SIXTH FIVE-YEAR REVIEW REPORT FOR ALLIED CHEMICAL & IRONTON COKE SUPERFUND SITE LAWRENCE COUNTY, OHIO

U.S. Environmental Protection Agency Region 5 Chicago, Illinois

9/10/2024

Figure 3 Location of Monitoring Wells with Clean-Up Goal Exceedances, Increasing Contaminant Concentrations and all Site Pumping Wells

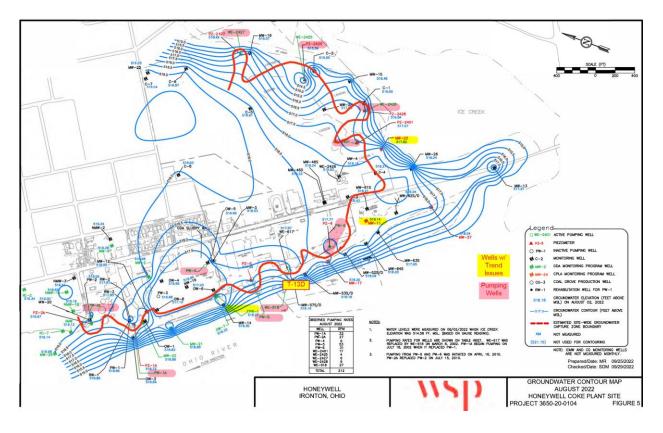
For the past five years (2017 to 2023), the CPLA well MW-23 has had 10 groundwater benzene exceedances of the 5 μ g/L CPLA Clean-Up Goal. Historically this well had a continuous decreasing concentration trend for Benzene from 1997 to 2017. However, since 2018 the benzene concentration trend has not been decreasing. Although the capture zone may have historically (2010 and prior) extended to Well MW-23's location, the well's location appears to be outside of the current area of hydraulic capture. See Figure 3. Benzene impacted groundwater leaving the site is not being captured.

Figure 7 – Arsenic

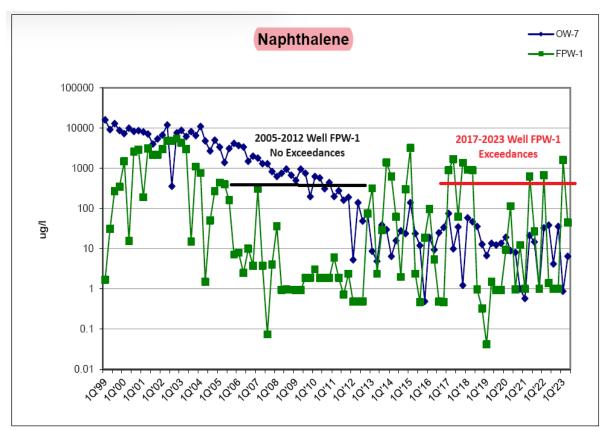
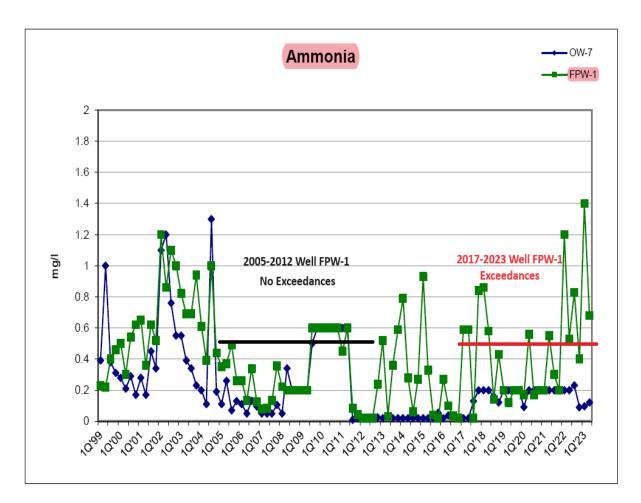
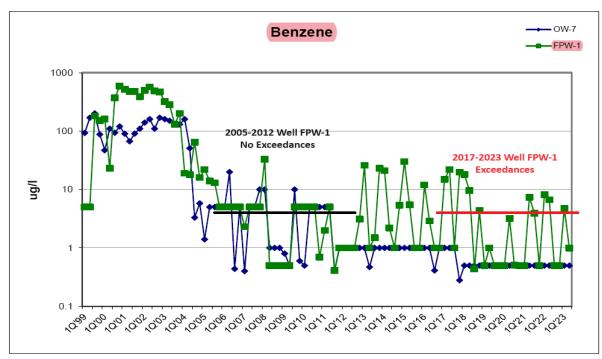
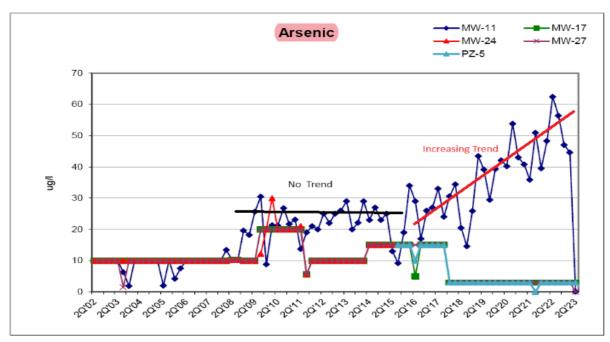
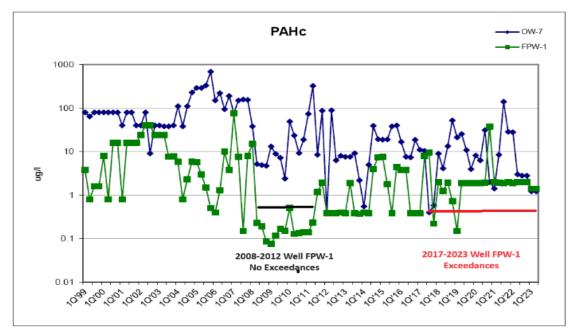
Because of years of groundwater pumping and treatment in the GDA, Well FPW-1 had achieved the GDA Groundwater Clean-Up Goals for ammonia, naphthalene, benzene, and PAHc by year 2005. The Clean-Up Goals were maintained for seven years until year 2012. After 2012 the rates of groundwater extracted was reduced, and Well FPW-1 started again to exceed the Groundwater Clean-Up Goals for ammonia, naphthalene, benzene, and carcinogenic PAH (PAHc). The well adjacent to FPW-1, Well OW-7 has had a significant number of exceedances of benzo(a)pyrene that has a 0.2 micrograms per liter (µg/L) GDA Clean-Up Goal. Although the Site's capture zone as depicted in the Quarterly Groundwater Monitoring Reports may have historically extended to Well FPW-1 and OW-7's location (2010 and prior), the well's location is outside of the current area of hydraulic capture. See Figure 3 (Appendix B). Contaminated groundwater leaving the Site is not being captured. Each contaminant with exceedances at Well FPW-1 is discussed below (see Figures 4-9 in Appendix B).

Ammonia: In the past five years 2017-2023 Well FPW-1 has had at least 11 exceedances of the 0.5 mg/L ammonia GDA Clean-Up Goal. Prior to year 2012 (2005 until 2012,) there were no exceedances of the ammonia GDA Clean-Up Goal.

Naphthalene: In the past five years 2017-2023 Well FPW-1 has had at least 11 exceedances of the 690 μ g/L naphthalene GDA Clean-Up Goal. Prior to year 2012 (2005 until 2012,) there were no exceedances of the naphthalene GDA Clean-Up Goal.

Benzene: In the past five years 2017-2023 Well FPW-1 has had at least nine exceedances of the 5 μ g/L benzene GDA Clean-Up Goal. Prior to year 2012 (2005 until 2012,) there were 10 exceedances of the benzene GDA Clean-Up Goal.

PAHc: In the past five years 2017-2023 Well FPW-1 has had at least nine exceedances of the 0.5 μ g/L PAHc GDA Clean-Up Goal. Prior to year 2012 (2008 until 2012,) there were no exceedances of the 0.5 μ g/L PAHc GDA Clean-Up Goal.

The CPLA well MW-11 has had four recent CPLA Clean-Up Goal exceedances for arsenic in the past five years 2017-2023. Starting around year 2016 there appears to be a significant increase in arsenic concentrations. Prior to year 2020, there had not been an exceedance of the CPLA Clean-Up Goal of 50 μ g/L for arsenic. Although the depicted capture zone may have historically extended to Well MW-11's location (2010 and prior), the well's location appears to be outside of the current area of hydraulic capture. See Figure 3 (Appendix B). Arsenic impacted groundwater leaving the Site is not being captured.

Figure 10 - Tar Assessment & Vertical Profiles

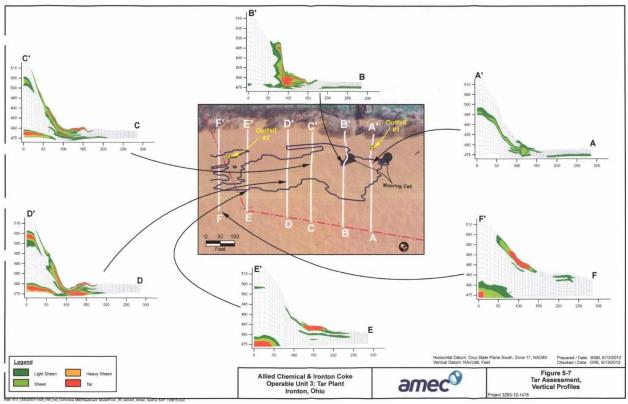
The 2012 Final Pre-Design Report (Honeywell, 2012) included a limited Tar and Sheen Assessment that delineated the vertical distribution of contamination. It predicted that tar and sheen occurred within the three to five-foot layer of cobbles along much of the bedrock surface underneath the Ohio River. Four concurrent cross sections across the river showed significant Tar within the cobble zone extending from the Tar Plant to under the Ohio River at the northwestern end of the Tar Plant assessment area. These four concurrent cross sections (labeled C-C" to F-F") clearly show a contaminant pathway from the number of mapped DNALP pools under the Tar Plant migrating under the Ohio River. The significant pumpable DNAPL area adjacent to the GDA was not included in limited Tar and Sheen Assessment.

Figure 11 – Solar Production Logs for Years 2022 through 202

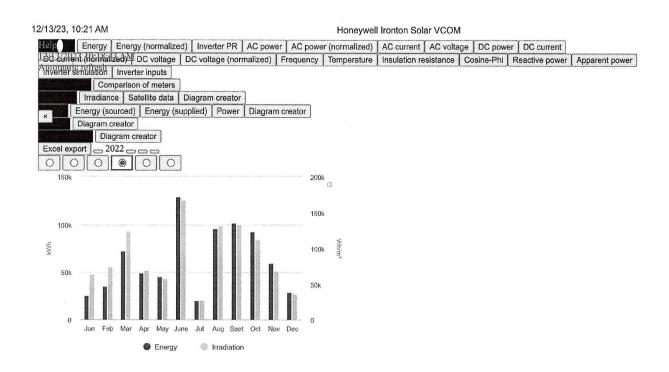
- The Solar Panels located on OU3 Tar Plant was closely inspected. It was evident that the nonpenetrating solar array racking system does not provide any disturbance to the cover/containment cap. The solar array is running at about 70% capacity while Parsons is continuing to troubleshoot and optimize the system. The production logs for 2022 and 2023 are provided in Figure 11 (Appendix B).
